7 March 2023

DA/2022/826 - 79 Wigram Road Glebe 2037

Figure 1- South East and South West Elevations of the proposed rear extension

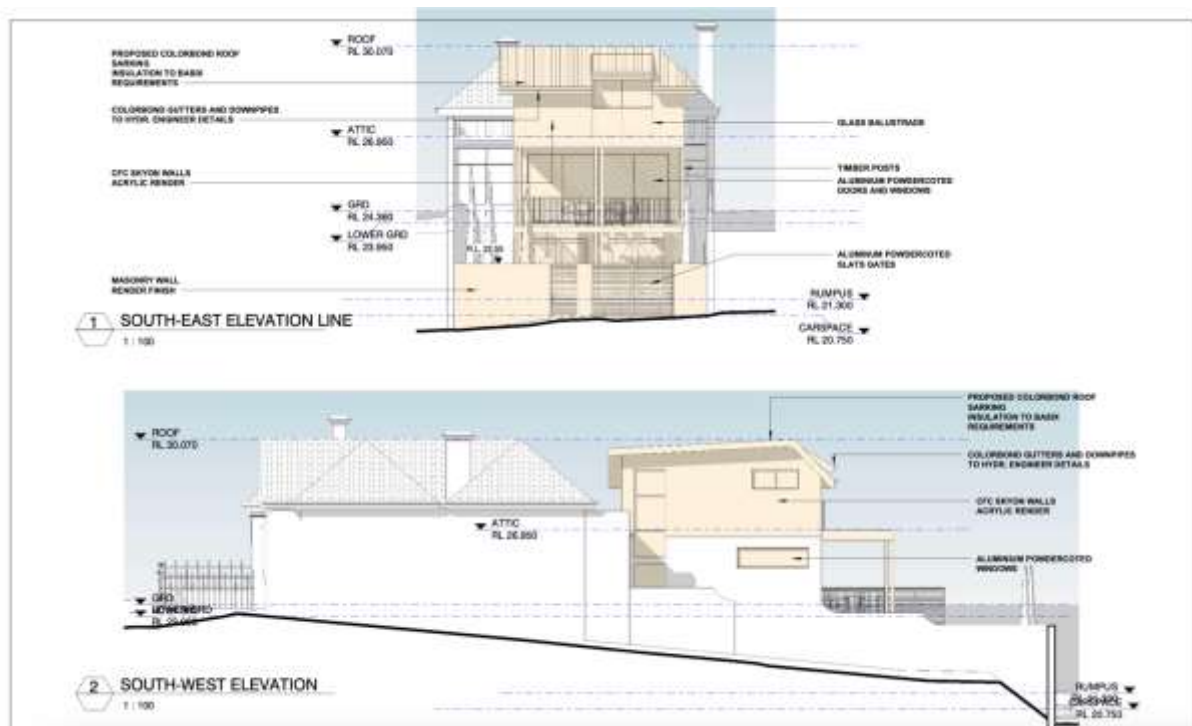
The submitted Architectural Drawings (Figure 1) highlights significant bulk and scale of the pavilion and how incongruous it will be to the character of the Toxteth Heritage Conservation Area.

The bulk and scale of this proposal would be more acceptable to the character of the Toxteth HCA if the following redesign were to occur:

- The external elevations to the master bedroom etc atop the rear extension reads as an attic entirely within a hipped roof profile
- All windows within the hipped roof to follow the controls for dormer windows
- Sliding doors with a glass balustrade that suggests a balcony profile are removed
- Tree replacement and appropriate landscaping be used to both maintain and improve the existing tree canopy whilst diminishing the impact of the height, bulk and scale of the development

Contrary to the above Planning Control and the overall setting of the 3 dwellings, the proposal seeks to ignore the hipped roof setting of 77 and 81 and propose a full height wall to the south west (visible from Wigram Lane) and north west elevations (not visible), and a mid-height wall to the other two elevations with a token representation of a hipped roof element.

The proposal can easily be interpreted as a three storey development as detailed in the south east and north west elevations images shown in Figure 1.. The full length window and double sliding door places the interpretation beyond doubt.

The proposed window facing Wigram Lane, reads as a full length sliding double doors adjacent a glazed balustrade.

Figure 3 – indicative Pavilion addition as illustrated In the City of Sydney DCP

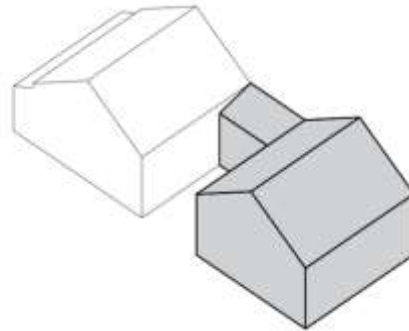
Section 4.1.4.4 of the DCP permits pavilion additions. Specific to this proposal is subclause (1) which reads: *“The roof pitch of pavilion additions must respect the roof pitch of the existing building, and be suitable to the particular building and its setting as shown in Figure 4.9 Example of a pavilion addition. “*

Figure 10 – City of Sydney Urban Forest Strategy – Canopy Cover loss in Glebe since 2008

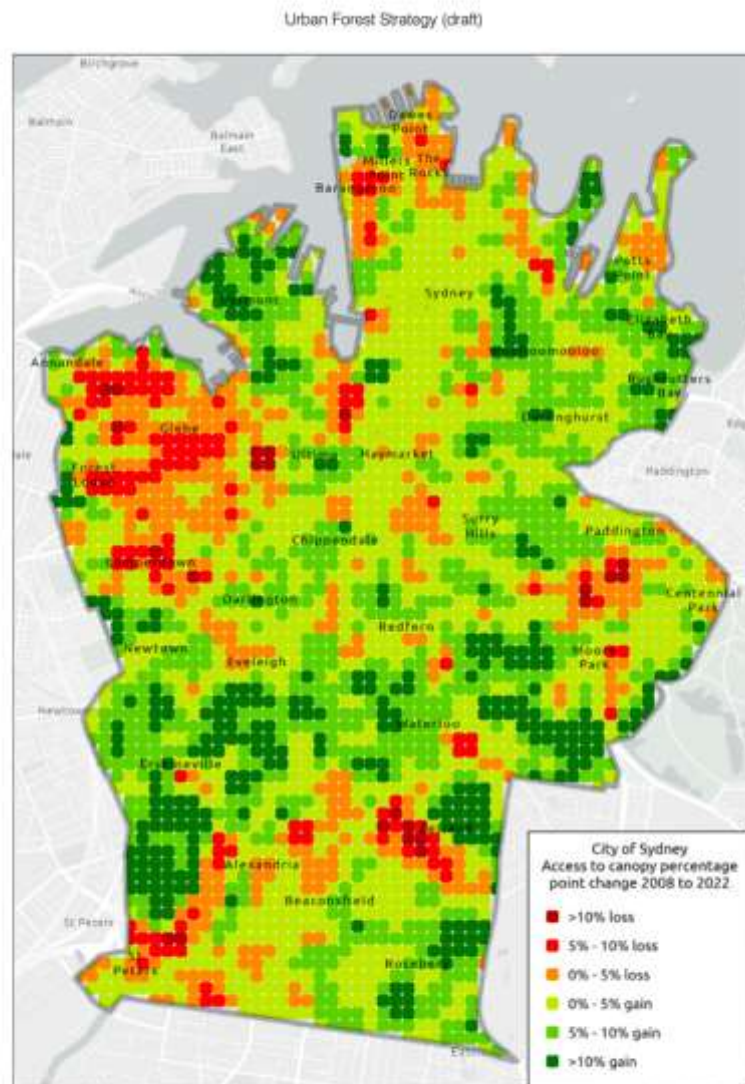
Firstly, the current City of Sydney Draft Urban Forest Strategy advises that the reduction in the tree canopy cover in Glebe on privately owned land is due to over development. The draft Strategy seeks to reverse the trend with increased targets at development time. Although the strategy and targets are in draft form, it

would be environmentally irresponsible not to replace this tree elsewhere within the landscaping if it must be removed.

The extent of canopy cover in Glebe between 2008 and 2022 is unacceptable.
